Croft Medical Centre – Response to Highways comments in relation to the proposed replacement Medical Centre (Ref: EG/57/16/PL)

1. This note sets out the comments made by West Sussex County Council (WSCC) in relation to the proposals to construct a replacement Medical Centre on the plot of land to the west of the existing facility in Eastergate.

SUBJECT: EG/57/16/PL

(Drawing 2016-2889-DWG-203)

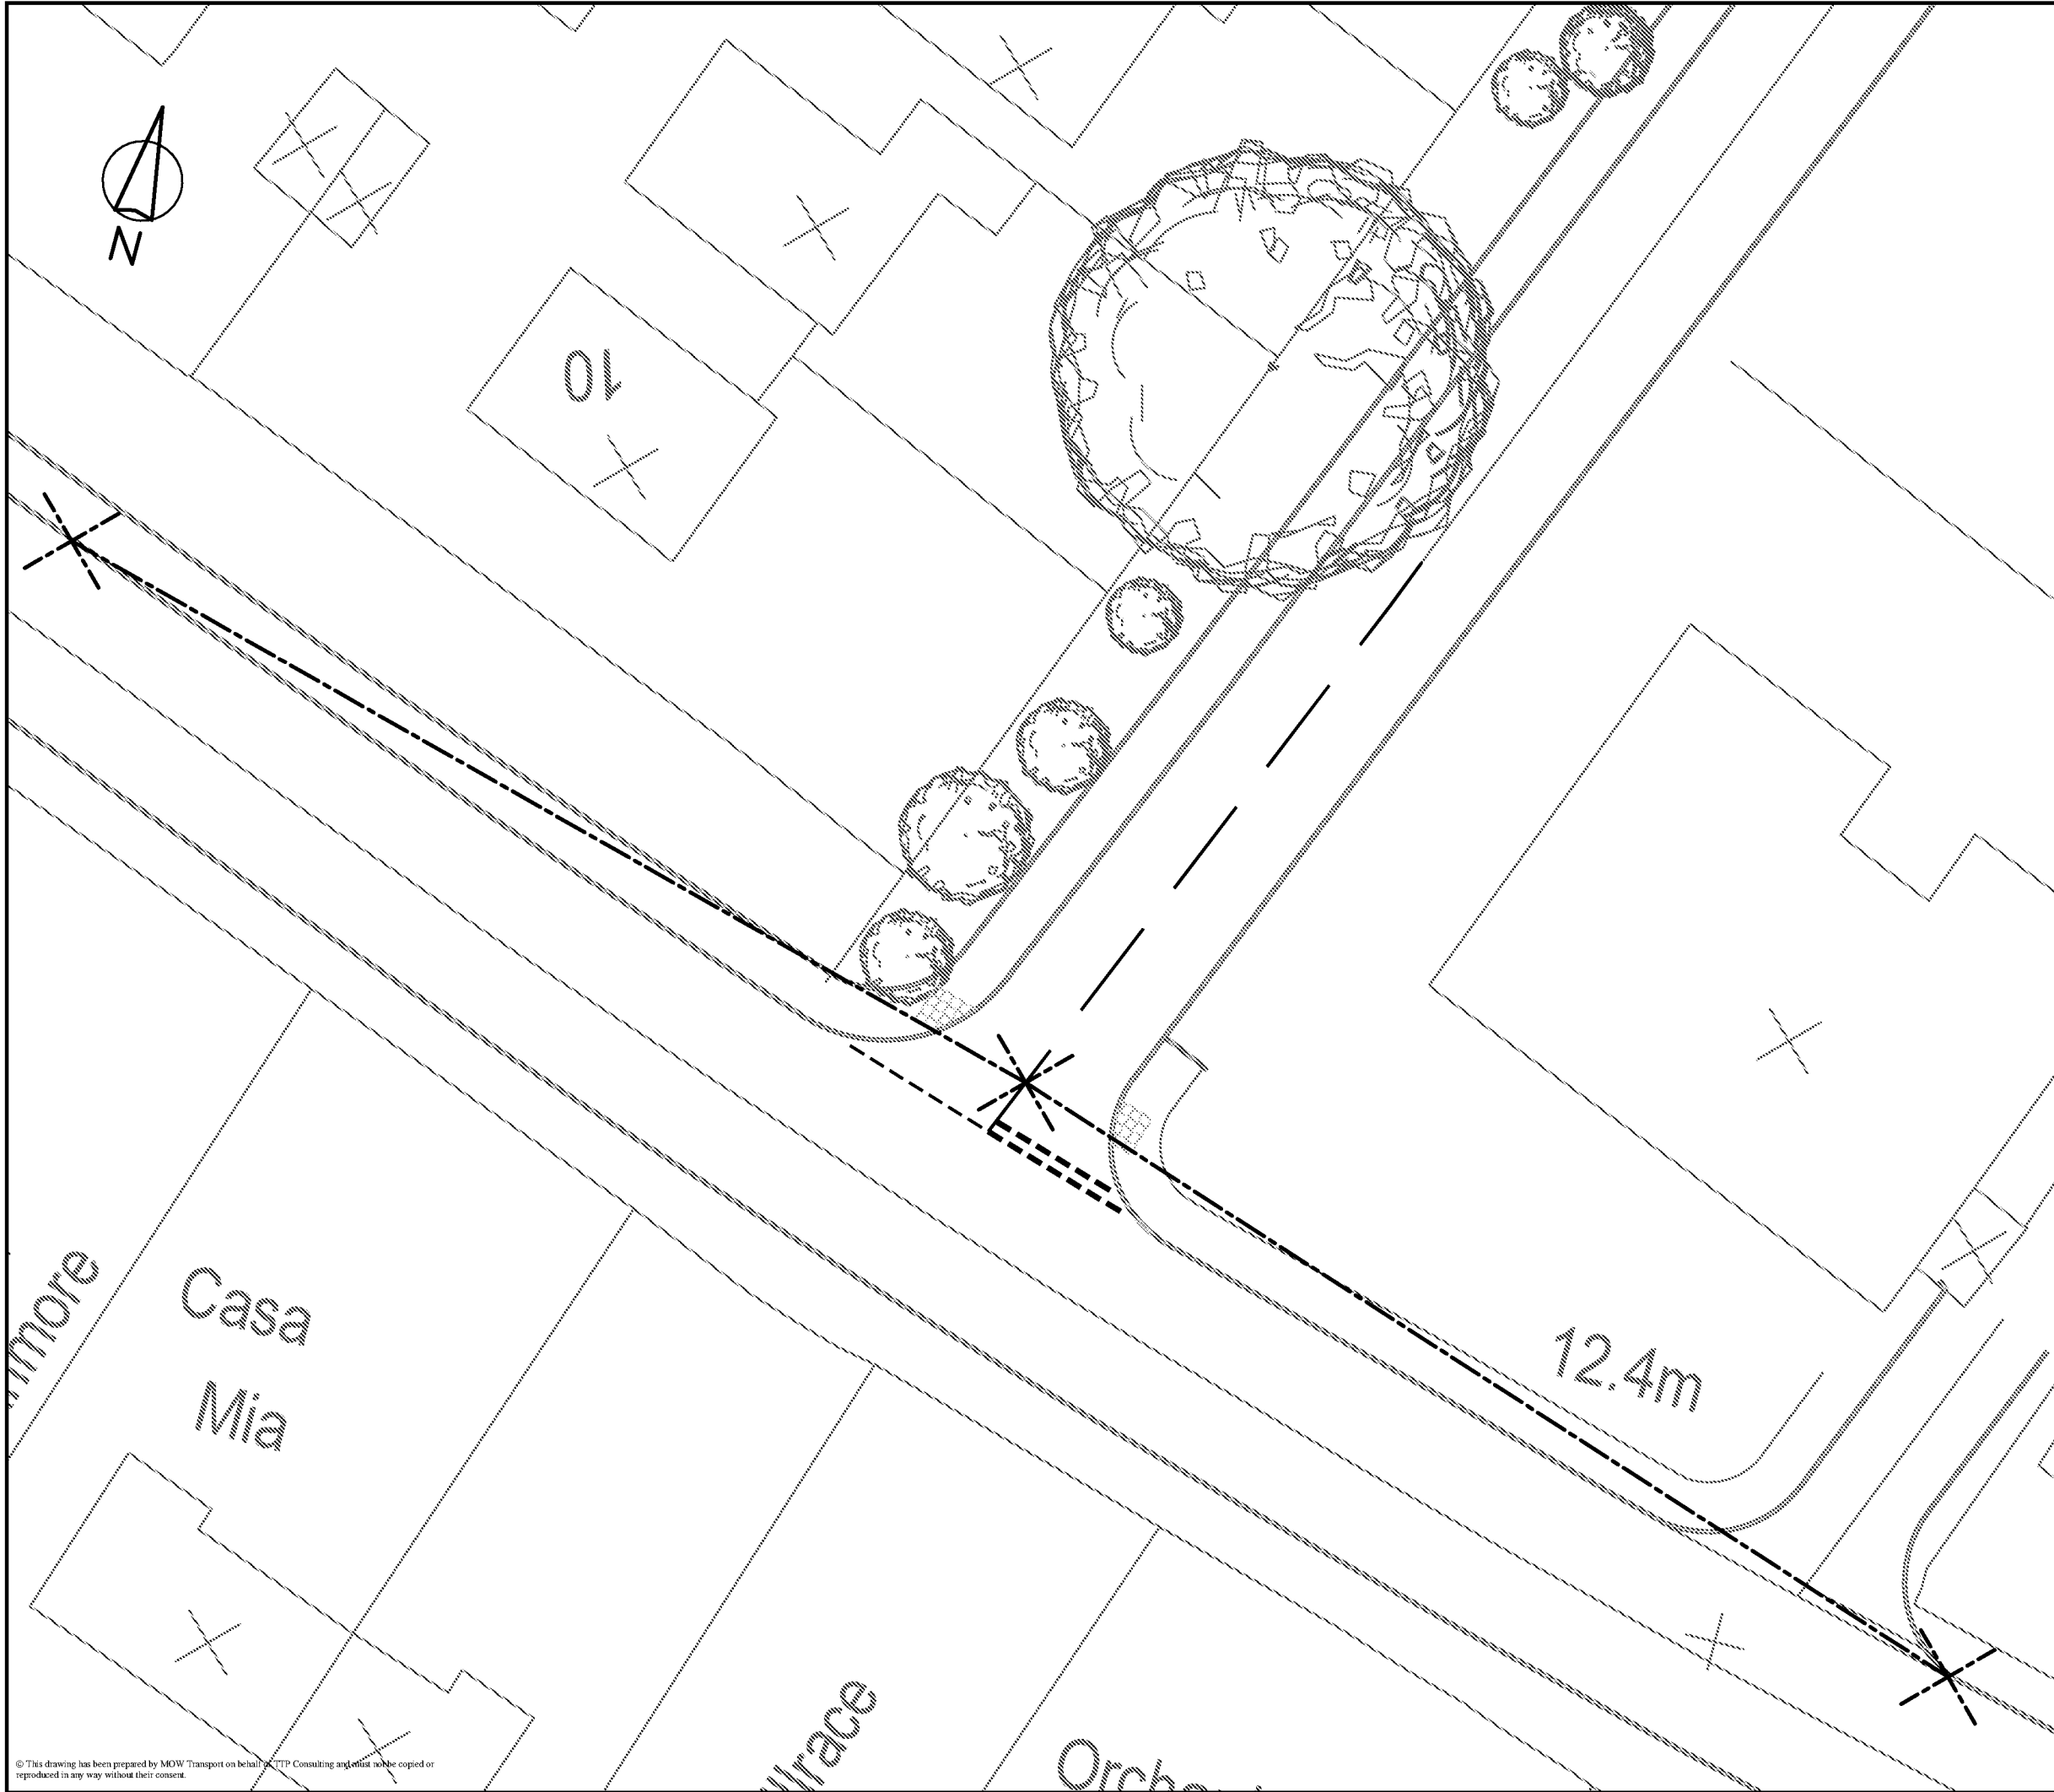
The proposed site has an existing vehicular access/crossover that presently serves a staff car parking area. This access is to be upgraded to a bellmouth with appropriate kerb radii. No plan has been provided to demonstrate how the access will work or how

it relates to the overall site access arrangements. A scaled plan detailing the access works needs to be submitted to be assessed. Visibility splays of 43m in each direction from a 2.4m setback should also be demonstrated.

Location: A (drawing 2016-2889-DWG-203) – Site Access Road

Summary: Side road gradient

It was observed that the existing unmade access road slopes down to Barnham Road. A future side road slope could result in vehicles rolling forward into the path of southbound vehicles on Barnham Road.

RECOMMENDATION It is recommended that the detailed design includes a flattish section of access road to the give way line to reduce the risk of roll forward incidents.

Location: B (drawing 2016-2889-DWG-203) – Barnham Road

Summary: Pedestrian desire line

It was observed that there is a northbound bus-stop located a short distance to the south of the proposed access, but no existing crossing point for pedestrians to cross Barnham Road.

RECOMMENDATION It is recommended that the Designer reviews the need for a formal dropped kerb crossing point between the access and the bus stop to assist pedestrian movement/desire lines.

Access/Visibility The proposed site has an existing vehicular access/crossover that presently serves a staff car parking area. This access is to be upgraded to a bellmouth with appropriate kerb radii. No plan has been provided to demonstrate how the access will work or how it relates to the overall site access arrangements. A scaled plan detailing the access works needs to be submitted to be assessed. Visibility splays of 43m in each direction from a 2.4m setback should also be demonstrated.	Drawing 2016-2889-DWG-203 (Annex B) illustrates the 2.4m by 43m visibility splays from the proposed junction.

2.3 JUNCTIONS 2.3.1 PROBLEM Location A: (drawing 2016-2889-DWG-203) – Site Access Road Summary: Side road gradient. It was observed that the existing unmade access road slopes down to Barnham Road. A future side road slope could result in vehicles rolling forward into the path of southbound vehicles on Barnham Road. RECOMMENDATION: It is recommended that the detailed design includes a flattish section of access road to the give way line to reduce the risk of roll forward incidents.	The detailed design will review the gradients on the approach to the junction with Barnham Road to provide appropriate gradients at the junction taking into account the existing gradients, drainage and reducing the risk of vehicles rolling forward.

2.4 NON-MOTOR VEHICLE PROVISION 2.4.1 PROBLEM Location B: (drawing 2016-2889-DWG-203) – Barnham Road Summary: Pedestrian desire line It was observed that there is a northbound bus-stop located a short distance to the south of the proposed access, but no existing crossing point for pedestrians to cross Barnham Road. RECOMMENDATION It is recommended that the Designer reviews the need for a formal dropped kerb crossing point between the access and the bus stop to assist pedestrian movement/desire lines.	The need for a dropped kerb / formal crossing point will be reviewed at the time of the detailed design and provided if deemed appropriate / necessary.
2.5 SIGNS AND LIGHTING 2.5.1 No problems identified in this category at this Stage 1.	Noted

(Revised Layout)

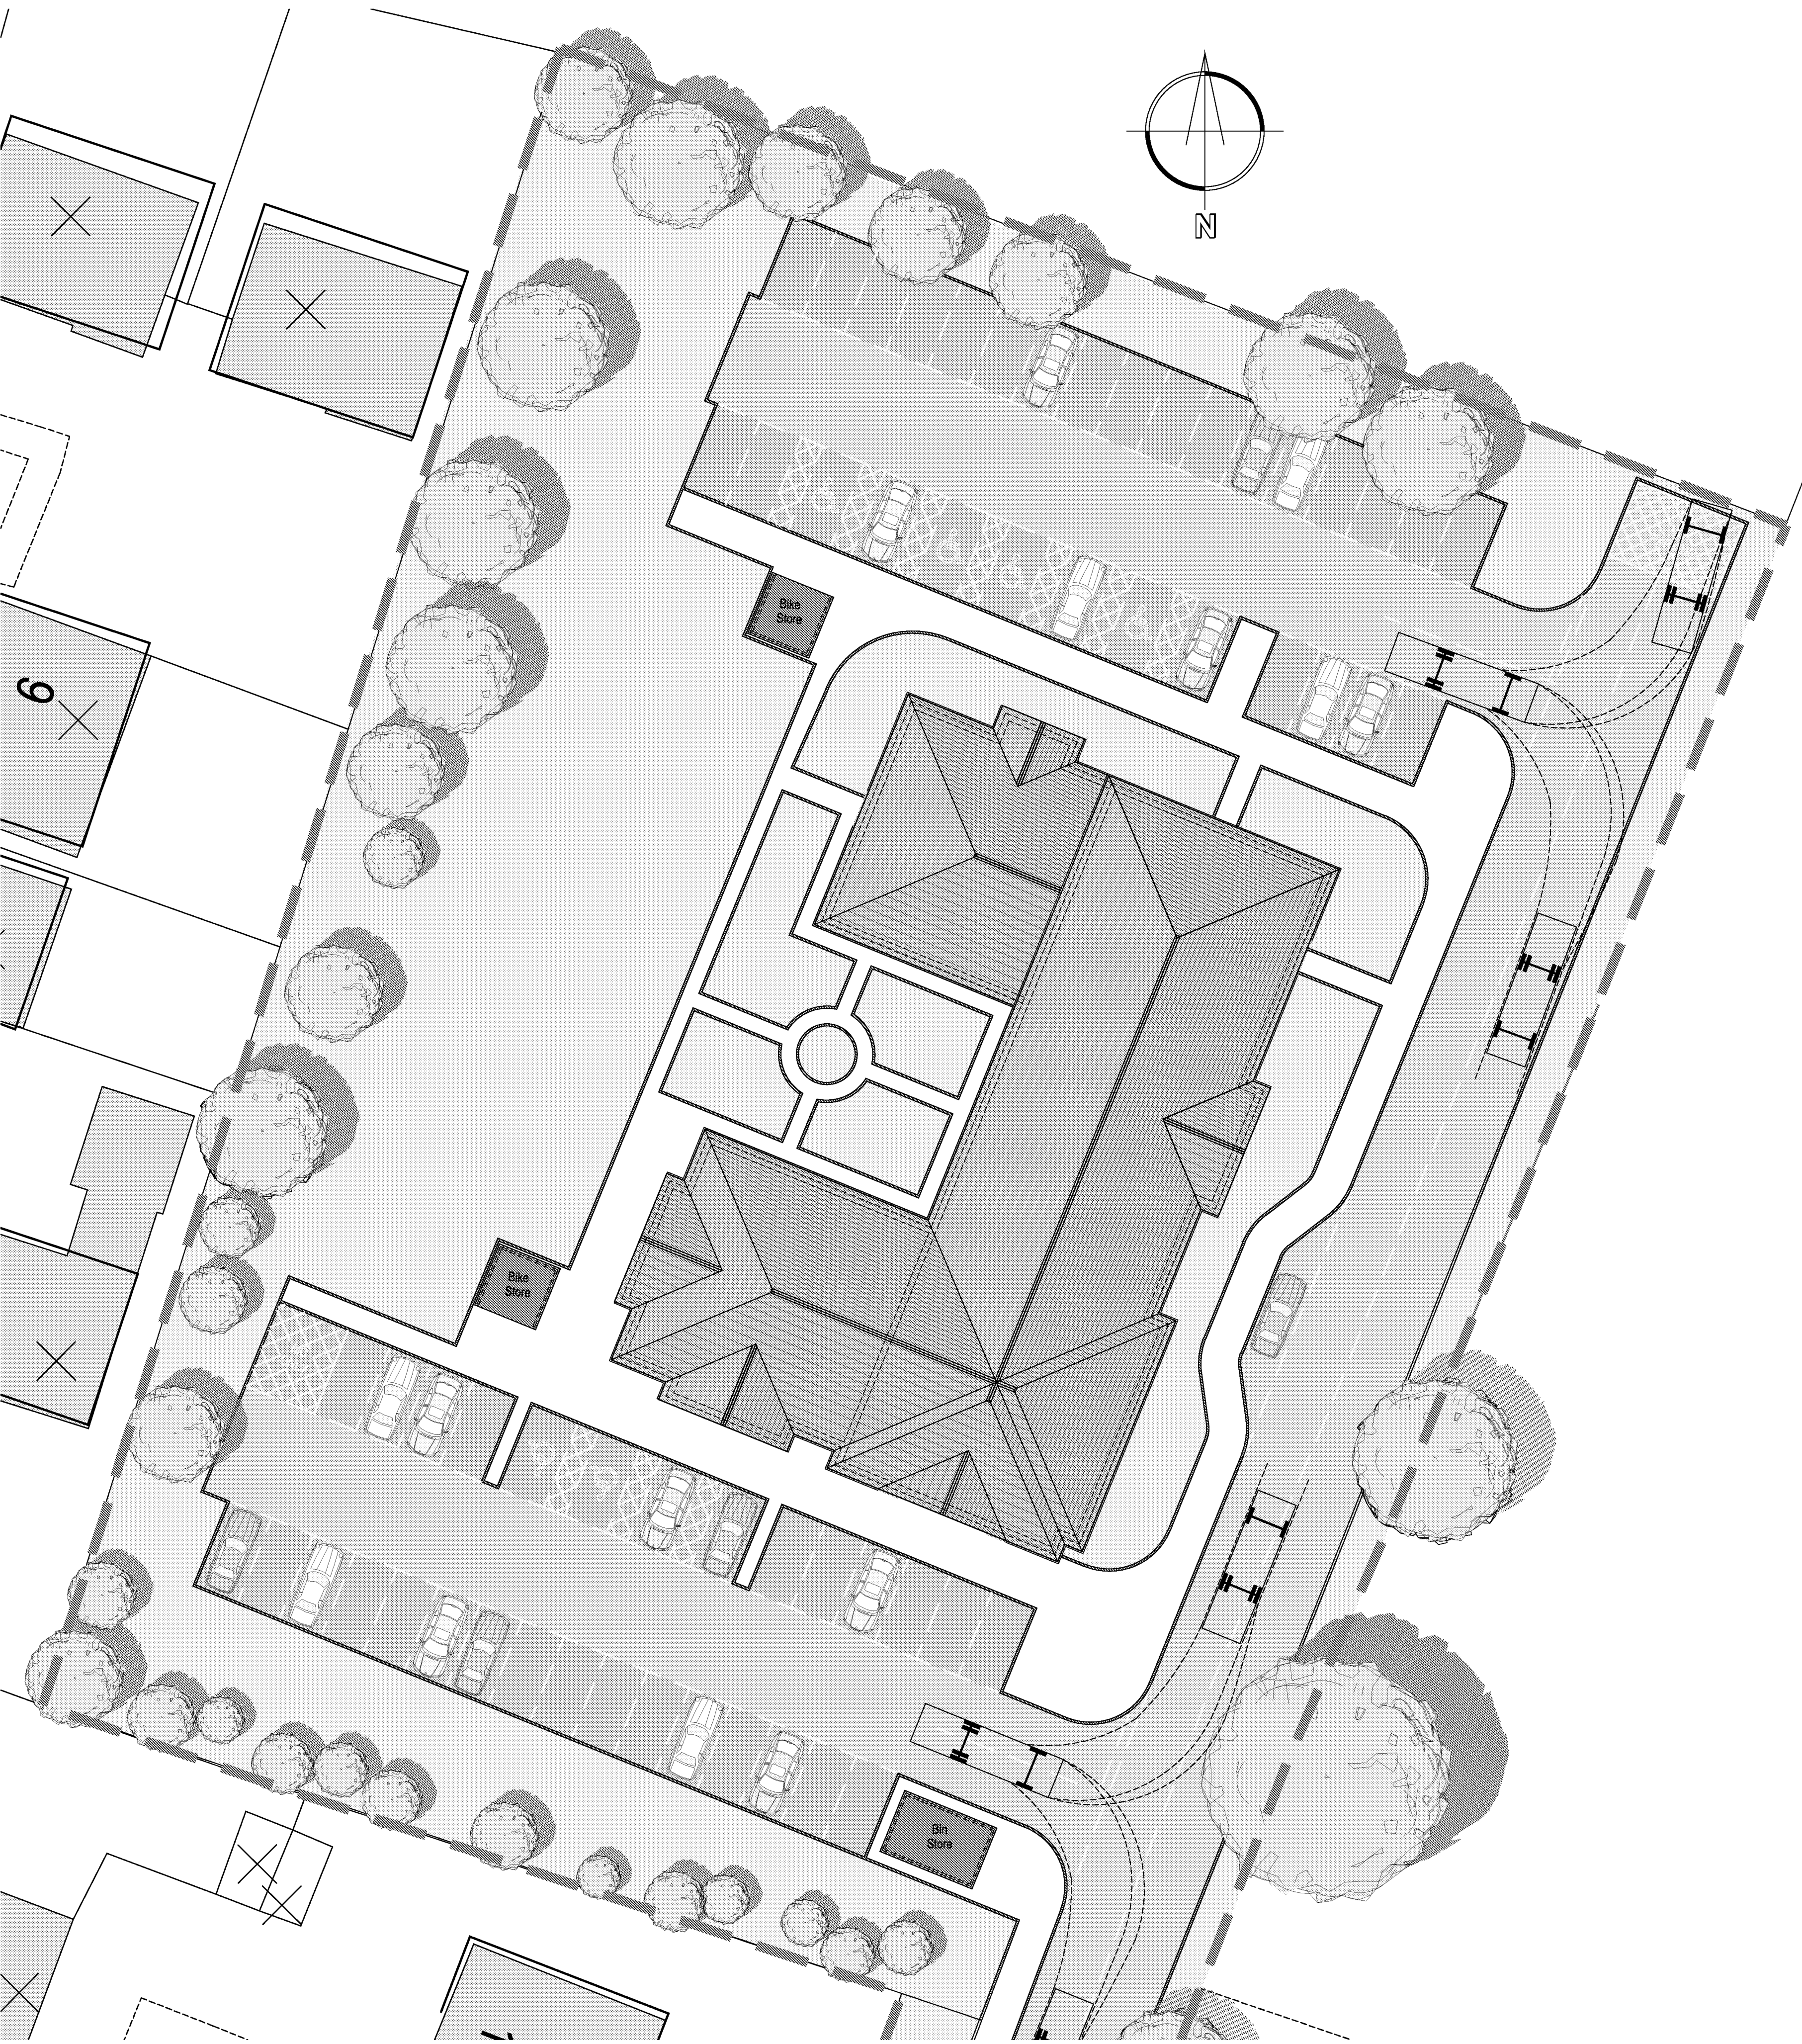
The WSCC Parking Standards for medical surgeries are detailed and are based on the number of practitioners, the number of consulting rooms, and admin/office space. The proposed provision of 56 spaces falls short given the requirements of the WSCC Parking Standards.

It is noted that section 5.07 of the Design & Access Statement indicates that the 28 parking spaces to the south of the building will be for visitors to the surgery, whilst the 26 spaces (including 7 disabled spaces) to the north of the building will be mostly for staff. This will also serve as overspill for the front car park should the practice experience higher than anticipated levels of visitors. Given that the existing surgery provides 28 spaces for patients and a separate staff car park with 15 spaces, the LHA are concerned that the combined number of parking space for visitors and staff as proposed will be insufficient given the increase in size of the building and consulting rooms. There would be more people visiting the site and more staff to operate the surgery. The LHA would advise that given the known access and parking issues of the current surgery the applicant submits a revised parking strategy, taking on board the standards referred to under the WSCC Parking Standards.

Road Safety Audit (Stage 1) There has been no audit submitted with this application. A development of this size would require a Stage 1 Road Safety Audit in line with the WSCC Safety Audit Adopted Policy.	A copy of the Stage 1 Road Safety Audit and the Designers Response is included at Annex C.
Parking There are known parking problems that have resulted from the use of the existing surgery at peak times. It is understood this was a driving factor behind the provision of the additional 15 spaces for staff. The WSCC Parking Standards for medical surgeries are detailed and are based on the number of practitioners, the number of consulting rooms, and admin/office space. The proposed provision of 56 spaces falls short given the requirements of the WSCC Parking Standards. It is noted that section 5.07 of the Design & Access Statement indicates that the 28 parking spaces to the south of the building will be for visitors to the surgery, whilst the 26 spaces (including 7 disabled spaces) to the north of the building will be mostly for staff. This will also serve as overspill for the front car park should the practice experience higher than anticipated levels of visitors. Given that the existing surgery provides 28 spaces for patients and a separate staff car park with 15 spaces, the LHA are concerned that the combined number of parking space for visitors and staff as proposed will be insufficient given the increase in size of the building and consulting rooms. There would be more people visiting the site and more staff to operate the surgery. The LHA would advise that given the known access and parking issues of the current surgery the applicant submits a revised parking strategy, taking on board the standards referred to under the WSCC Parking Standards. It is understood that there would be some essential car users, for which car parking should be provided. There is the opportunity to encourage less car dependency for those staff that are not	The layout has been amended following discussions with the council to increase the number of parking spaces for cars to 60 as per the plan in Annex D.
